State of California
CALIFORNIA AIR RESOURCES BOARD

**AMENDMENTS TO THE LOW CARBON FUEL STANDARD REGULATION AND TO
THE REGULATION ON COMMERCIALIZATION OF ALTERNATIVE DIESEL FUELS**

FINAL STATEMENT OF REASONS

November 2018

Figure 7. Average product shares (by energy) from major processing units in 43 refineries.

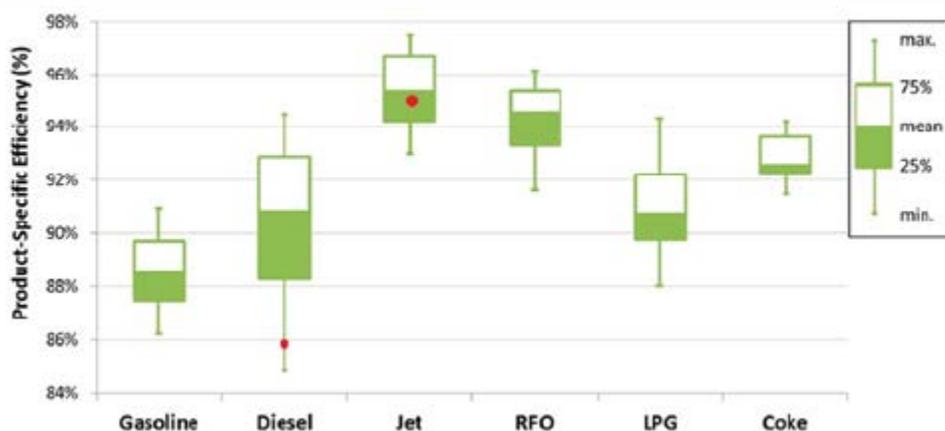
First, from a technical perspective, the proposal has incorrectly calculated the carbon intensity score for conventional jet fuel in California. Based on the CA-GREET3.0 Supplemental Document and Tables of Changes (March 6, 2018), the refining efficiencies used for petroleum jet fuel and ULSD in CA-GREET3.0 are 94.9% and 85.87% respectively. The difference between the two numbers - 9.03 percentage points - is a surprisingly large difference between two middle distillate products produced at the same California refineries. These numbers appear to be based on Linear Programming (LP) results for California refineries provided by Argonne. The reference, Elgowainy et al, indicated in the Supplemental Document includes the following table as Figure 7.

The original table does not include the two red dots which have been added here to illustrate the refining efficiencies used for petroleum jet and ULSD in CA GREET3.0. Based on this picture, we can see that ULSD refining efficiency used in CA-GREET3.0 represents a value close to the low-end of the diesel range; whereas the jet refining efficiency is close to the mean value of the jet range. The Elgowainy paper also indicates that the difference between production-weighted average efficiencies of diesel and jet fuel is 4.4 percentage points - which is less than half of the difference between refining efficiencies of petroleum jet and ULSD used in CA-GREET3.0.

Figure 7. Average product shares (by energy) from major processing units in 43 refineries.

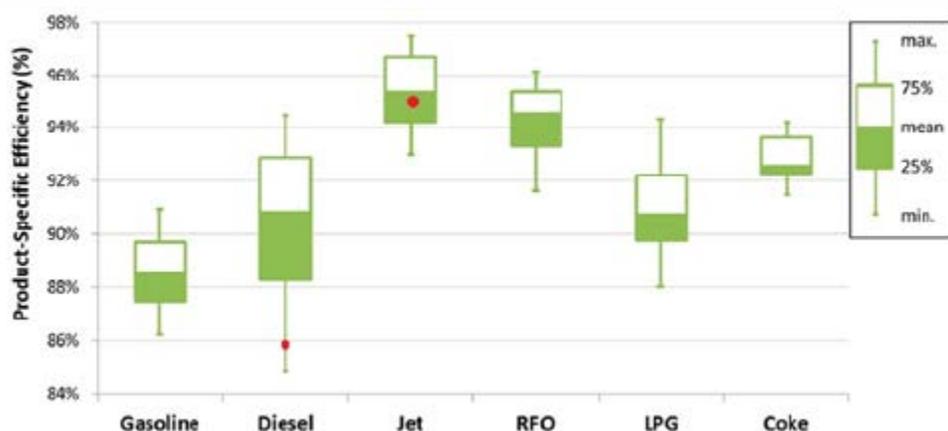
The original table does not include the two red dots which have been added here to illustrate the refining efficiencies used for petroleum jet and ULSD in CA-GREET3.0. This figure illustrates that the ULSD refining efficiency used to establish the CI value for conventional jet fuel represents a value close to the low-end of the diesel range;

Figure 2: EER of Propane Buses relative to Diesel Buses

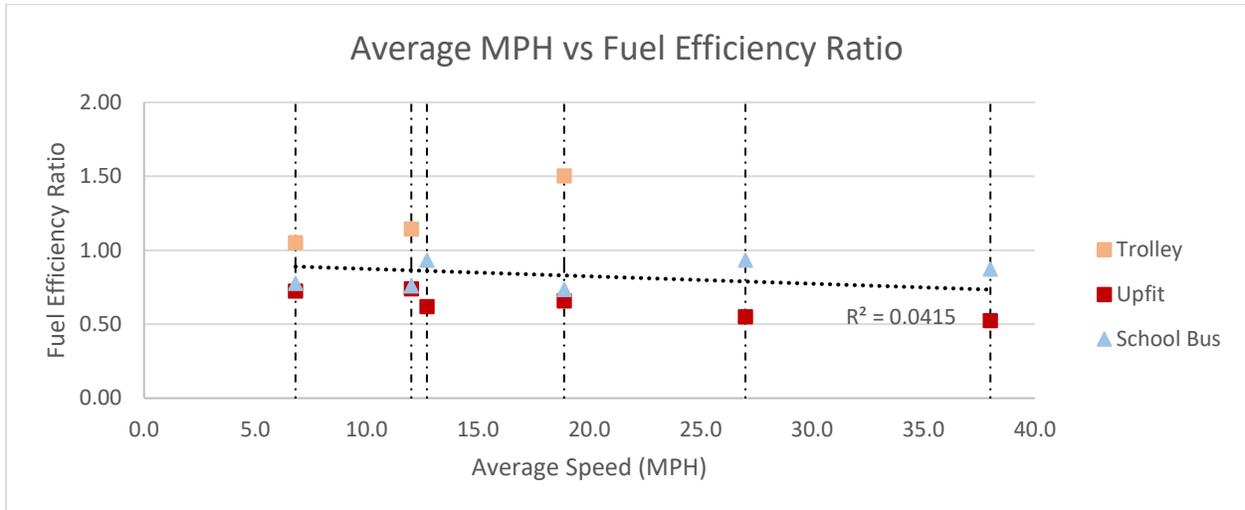
Figure 2 taken from the ISOR shows the EER values computed for three different LPG vs. diesel vehicle pairs labelled as "trolley", "upfit" and "school bus". The EER trend for the trolley with increased cycle average speed shows a different trend than those for the other two types, where the propane vehicle EER decreases with increasing speed.

Figure 1: Average range of the Nissan Leaf as a function of Ambient Temperature¹

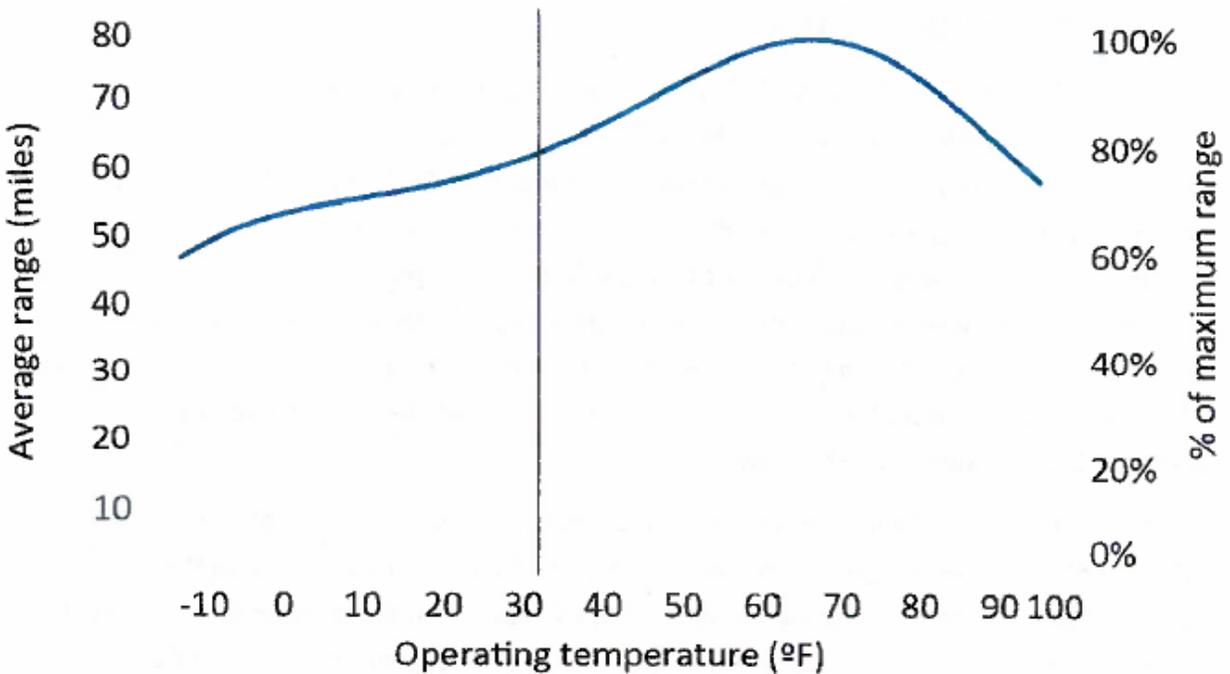
Comment: Ambient temperature affects the energy consumption in two ways – first by changing the energy consumption of the drivetrain and second, by requiring the use of air-conditioning or heating. As noted, these factors are not reflected in the standard dyno tests which are conducted at ambient temperatures of 70° to 75° F without the HVAC system being on.

Figure 1. Potential Loss in GHG Reductions and Windfall Revenue Transferred Under CARB’s Proposed Infrastructure “Capacity” Program

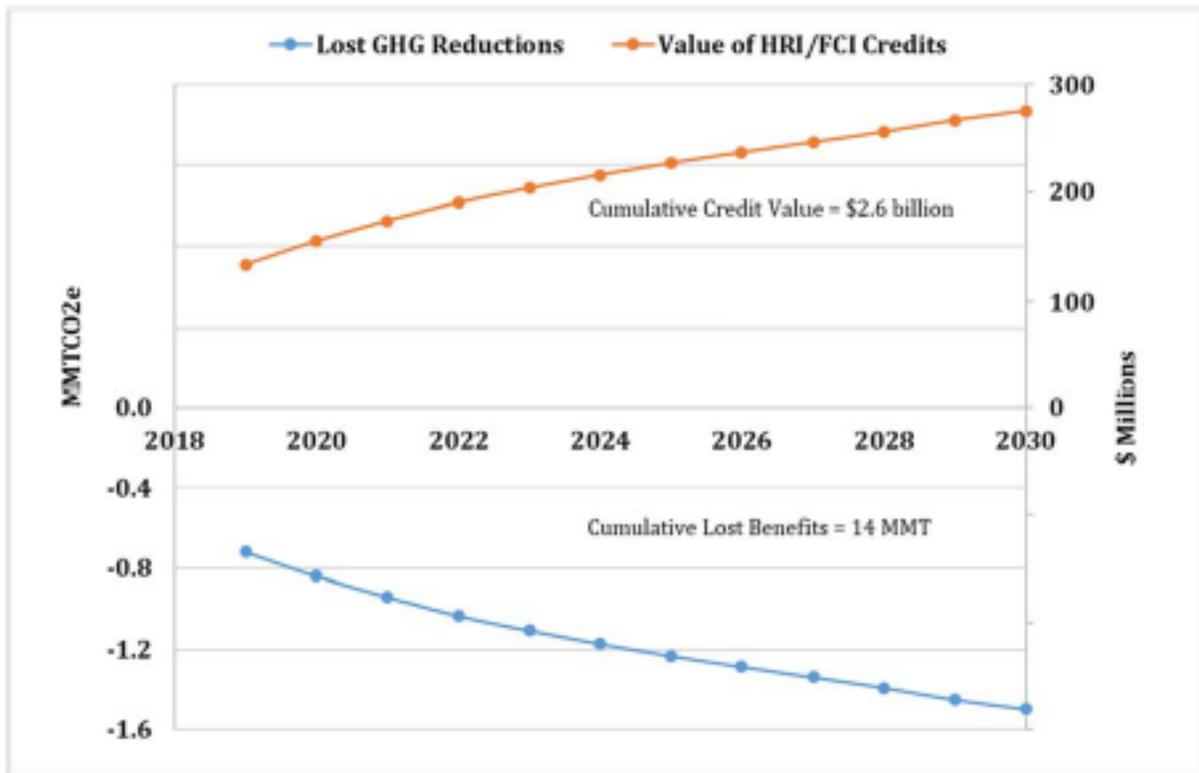
In order to put the potential magnitude of these issues into perspective, Figure 1 shows the estimated maximum amount of GHG reductions that could be lost due to the implementation of Section 95486.2 and the estimated maximum amount of windfall revenue that owners and operators of DC fast charging and hydrogen stations could realize based on the deficit values projected in the August 15, 2018 version of the Illustrative Compliance Scenario Calculator posted on CARB's website¹ as configured for the "Low Demand" and "Project/LD/Low ZEV/20%/infra" cases. The data in the figure assume that 5% of total deficits each year from 2019 to 2030 are provided as infrastructure credits and that the value of each LCFS credit received is \$184 – the average LCFS credit price for Q2, 2018. As shown, the annual amount of GHG reductions that would not be realized by the LCFS program due to the proposed infrastructure crediting provisions would range from about 0.8 to 1.6 MMTCO₂eq per year and the cumulative loss in GHG emissions from 2019 to 2030 could amount to 14.0 MMTCO₂eq. Similarly, windfall revenue received by operators and owners of DC fast charge and hydrogen stations could amount to about \$150 to \$300 million per year with the potential cumulative value being about \$2.6 billion. Under CARB's high fuel demand scenarios, lost GHG benefits and windfall revenues would be even greater. It should also be noted that CARB staff acknowledges in Attachment G to the 2nd 15 day notice that accounting for infrastructure credits for hydrogen and DC fast charges is one of the factors that lead to a reduction in the cumulative GHG benefits claimed for the LCFS program from 117 to 97 MMTCO₂eq (a loss of 17%) compared to the current conditions baseline and from 70 to 63 MMTCO₂eq (a loss of 10%) compared to the business-as-usual scenario.

Figure 2. Comparison of Revenue Associated with CARB Proposed Infrastructure Credits with Available Revenue from Recharging of Light-Duty EVs.

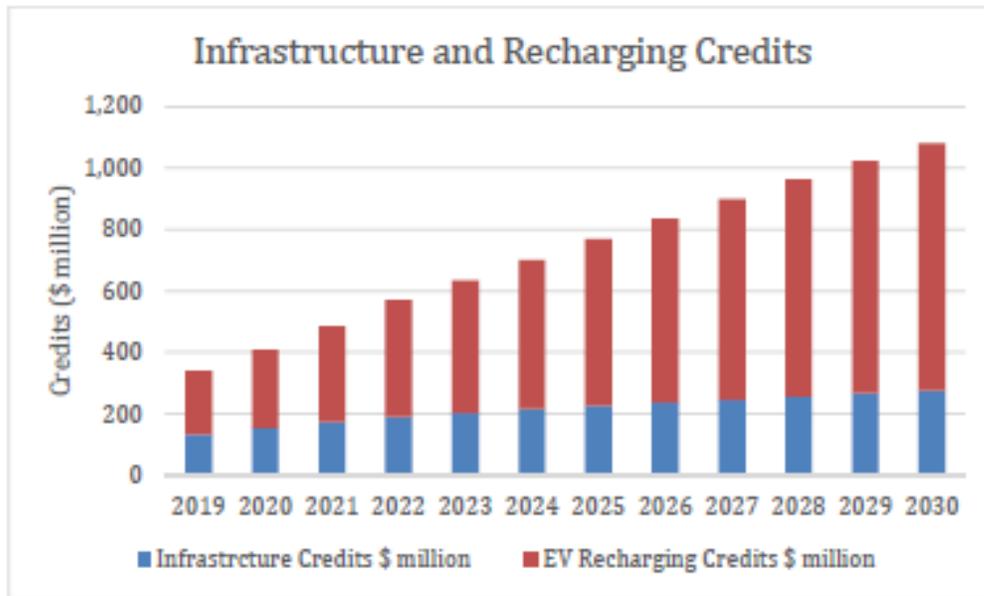
It appears that there should be ample funding available for EV/FCV infrastructure. Figure 2 compares the maximum values of the LCFS credits proposed by CARB staff for infrastructure, to the total value of credits from recharging of light-duty EVs as documented in the August 15, 2018 version of the Illustrative Compliance Scenario Calculator for the “Low Demand” and “Project/LD/Low ZEV/20%/infra” cases. As shown in Figure 2, the magnitude of the value of the infrastructure credits proposed by CARB is small compared to the value of the credits that EDUs receive from residential EV recharging. Although availability of DC fast charging to the extent that such capacity is actually needed could “*benefit the current or future EV drivers across California,*” CARB would simply have to change EV to “Zero Emission Vehicle (ZEV)” to allow for the use of funds from EV recharging to also support hydrogen station infrastructure, which could obviously benefit current or future FCV drivers across California.
